TOPICAL RESPONSE NO. 1: SCOPE OF THE RECIRCULATED PORTIONS OF THE EIR

NOTICE OF LOCAL PUBLIC MEETING
NOTICE OF A TIME EXTENSION FOR PUBLIC COMMENT ON THE DRAFT RECIRCULATED PORTIONS OF THE EIR FOR MISSION VILLAGE PROJECT
COUNTY PROJECT NO. 04-181 VESTING TENTATIVE TRACT MAP NO. 61105
SEA CONDITIONAL USE PERMIT NO. RCUP200500080 OAK TREE PERMIT NO. ROAK200500032
OAK TREE PERMIT NO. 200500043
CONDITIONAL USE PERMIT NO. (OFF-SITE IMPROVEMENTS) 200500081
(ON-SITE AND OFF-SITE GRADING AND IMPROVEMENTS)
PARKING PERMIT NO. 200500011
SUBSTANTIAL CONFORMANCE REVIEW NO. 201000001
STATE CLEARINGHOUSE NO. 2005051143

Figure 2. Santa Clara River Streamflow Duration Hydrograph

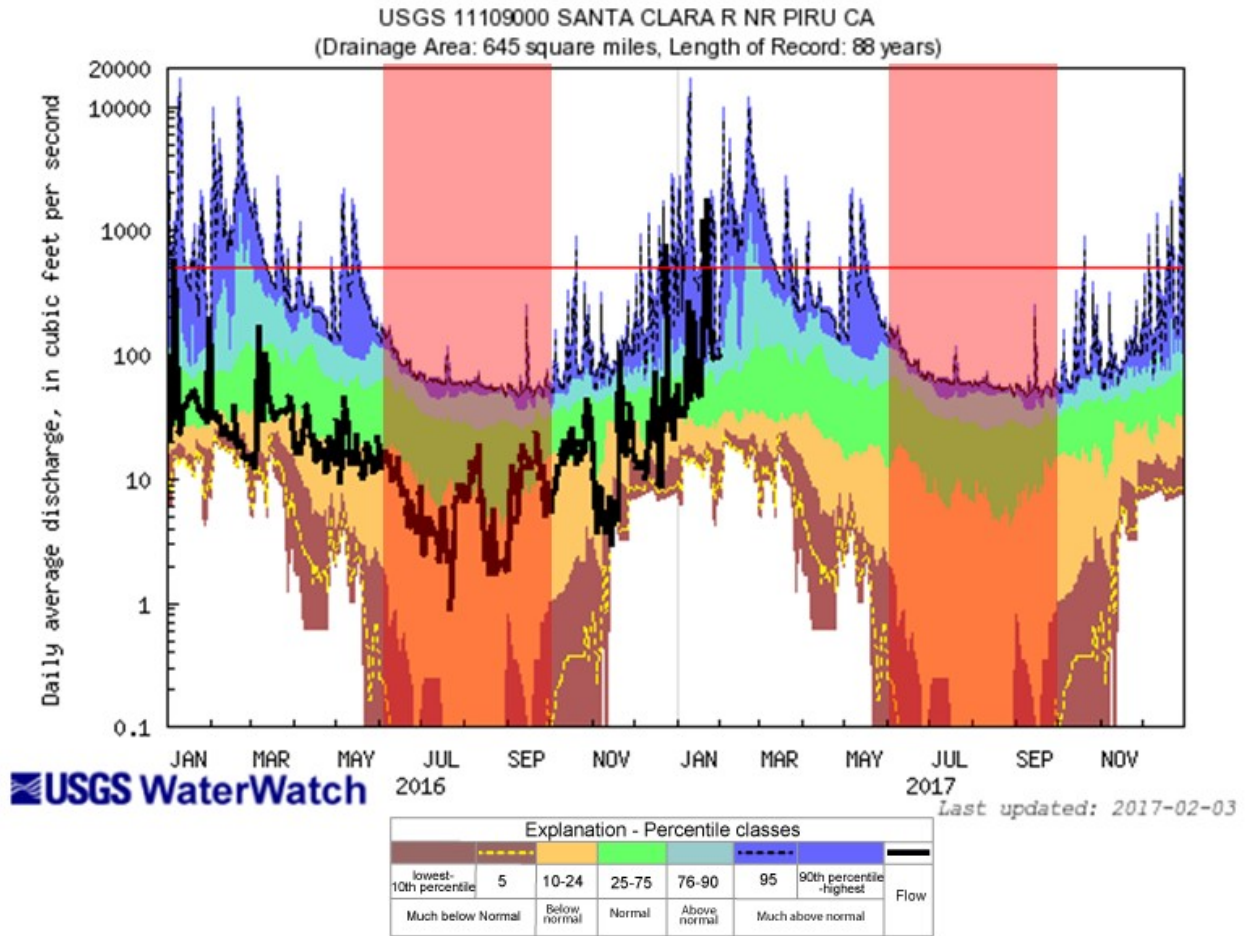
- Figure 2 shows the last 2 years of recorded flow data (black line) for USGS gage 11109000, the June through September dry season construction windows (pink boxes), and the 500 cfs value (red line). The colored areas show long-term statistics of streamflow for each day of the year at that station and the top of the dark blue area represents the maximum discharge recorded during

The comment describes Figure 2 from the Geosyntec 2016b memorandum, but does not raise any issue as to the adequacy of the Recirculated Analysis. Therefore, no further response is required.
